From: Thuaire, Charles
Sent: 15 October 2018 17:24
To: Planning
Subject: FW: URGENT - WATER HOUSE = 2018/4523/P 1 of 2 emails

Subject: URGENT - WATER HOUSE = 2018/4523/P 1 of 2 emails

As you are aware, on receipt of a planning alert to discharge Condition 5 2018/4523/P, my husband and I registered our objection in principle on 28th September 2018. The only submission from the Applicant was a Kate Gould Landscape Master Plan No: 106298 Rev A dd 10/9/18. No other details of the materials, excavation depths of the proposed hard landscaping works or construction methodologies were provided despite substantial landscaping works over the half acre site.

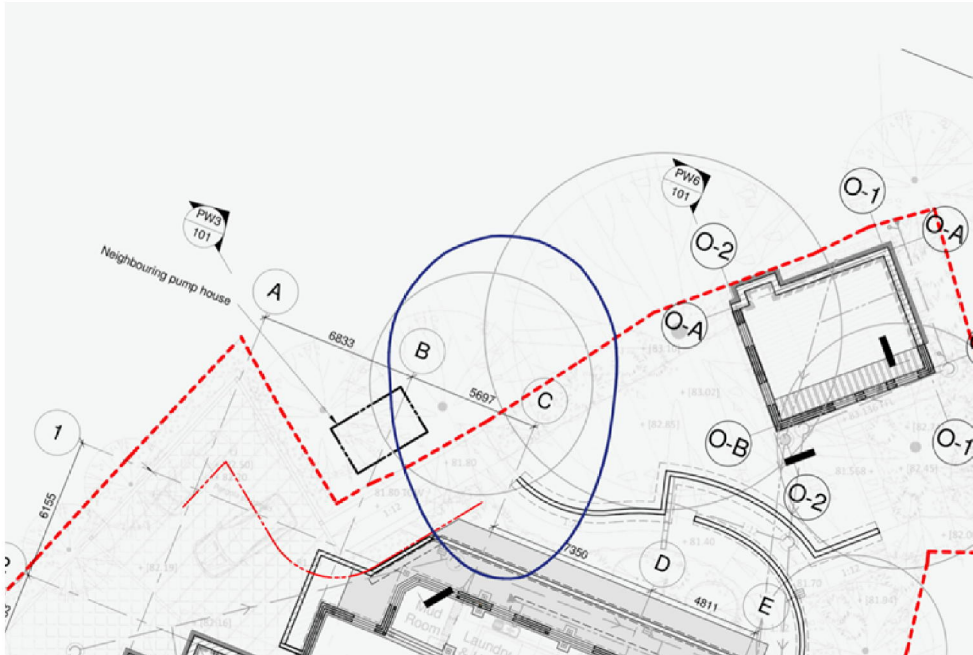
i) Our primary concern is potential construction impacts to our beech tree roots in the rear garden of the Water House where landscaping works along 40% of our boundary are proposed. (Full size drawings are included with the documents emailed under separate cover.)

iii) We sent all this information to the Applicant's team in early August (and thereafter two further times) but, to date, they have inexplicably not adopted the correct location of the tree or the extent of its asymmetric RPA. This can be seen most recently here on the Kate Gould Landscape Master Plan No: 106298 Rev A dd 10/9/18.

- i) the Kate Gould Landscape Master Plan is updated to show the correct location of our beech roots;
- ii) the proposed hard landscaping works and other works are then overlaid on that Landscape Master Plan;
- iii) Kate Gould provides the exact details of the proposed works along 40% of our L-shaped boundary and, importantly, also provides the method statement for these works given that they encroach into our beech root protection zone; and
- iv) all these documents are sent to Camden so that they become part of the formal planning process.

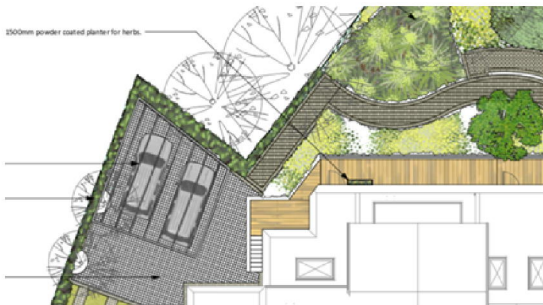
ii) In order to resolve the professional disagreement as to the extent, if any, of Beech roots in their rear curtilage we paid for Peter Barton Associates to undertake an expert root radar survey in July. We used Peter Barton in part because of his professional relationship with Adam Hollis from Landmark Trees who uses him on other projects and trusts his professional reputation. Peter Barton's findings were unequivocal. Significant Beech tree roots exist below their rear lawn as shown by the blue outline in the screen shot of the CAD drawing here, compared to the Applicant's drawing in grey beneath. Peter Barton's full report is also included in our supporting documents for your information.

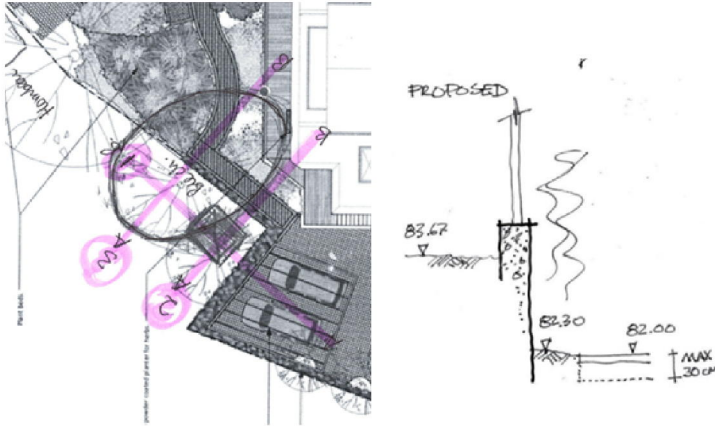
iv) After a discussion with the architect on 28th September we requested three cross sections showing the extent of works across our boundary as per the sketch below. Please note our ground level is 1.5m higher than the Water House on the corner by the pool plant room. KSR sent some nominal boundary wall sketches (not to scale) but these have not been provided to the Council and omit the area by their proposed parking bays.
